**REMARKS**

In an Official Action dated March 2, 2006, the Examiner rejected the pending claims, objected to the drawings and the specification. Applicants request that the Examiner reconsider the rejection of claims 1-4 and 21 and favorably consider newly presented claims 22-30.

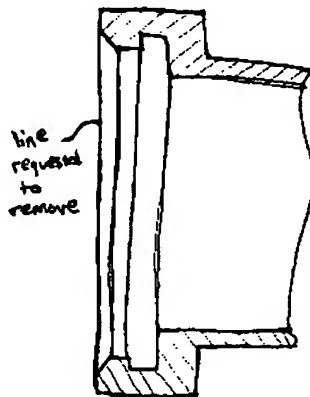
The Examiner has objected to the drawing in Fig. 2 as improperly showing the chamfer on the flange 55. As previously mentioned, the flange is drawn correctly.

In the following drawing, the outer sleeve is shown separated from the rest of the mounting device and the sectional is taken along a different line so that the sectional view shows the solid portion of the outer sleeve. The line that the Examiner has requested to be removed is shown in the drawing. As can be seen in the following drawing, clearly the line from the chamfer is visible in the figure. Similarly, in Fig. 2, the line would also be visible except that other components are covering the line except for the short line element that the Examiner has requested be removed. Since the lines are proper, Applicant requests that the Examiner reconsider the objection to the drawings.
